Subject: A) Improved attachment of the RPM-sensor
B) Improved attachment of the fuel pump
C) Upgrade of the hardware of the power-plant instrument
D) Exchange of manual pages

Applicability: All ASW 28-18E, Type Certificate EASA.A.034, all S/N up to 28742 inclusive, serial standard from S/N 28743 on

Classification: Minor modification

Position of the involved parts:

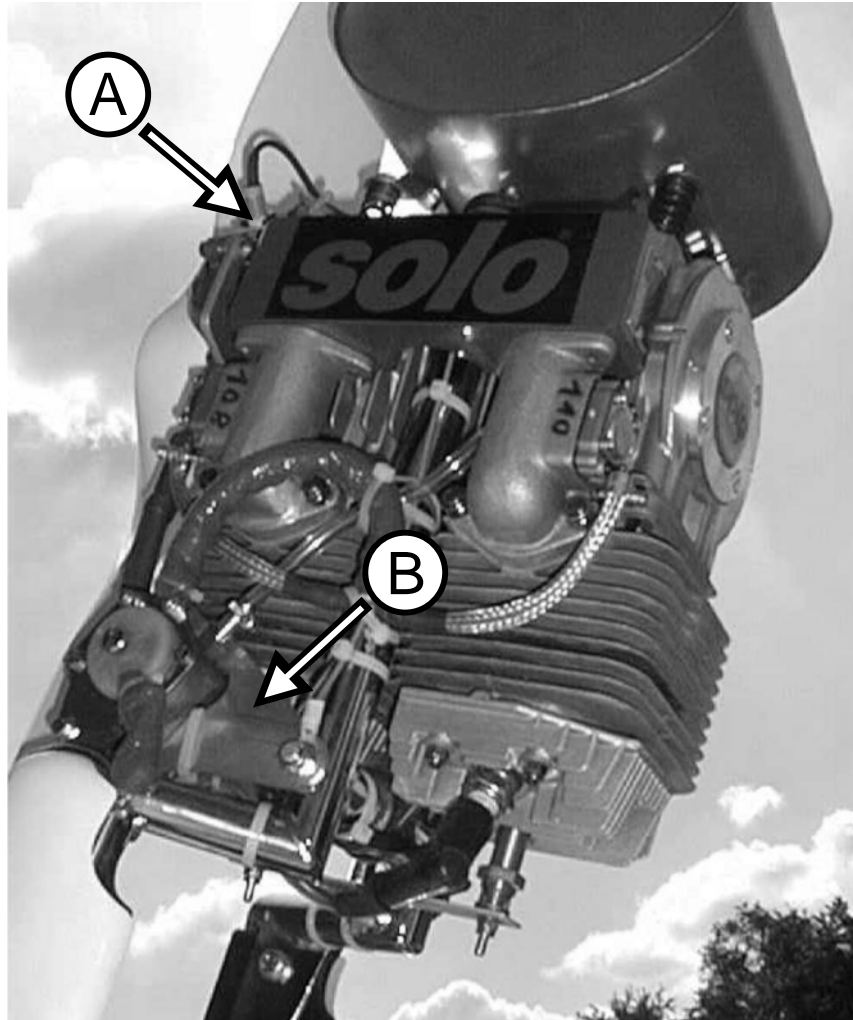
Action: A) The attachment made of FRP (850.72.203) replaces the aluminium part (850.72.0021).
B) The attachment plate (850.72.0088) of the pneumatic fuel pump is replaced by a more convenient formed part.

When installing the speed sensor again, a distance of 6±1mm has to be adjusted between sensor and magnetized side of the pole wheel.
The screw connections have to be secured with Loctite 242.
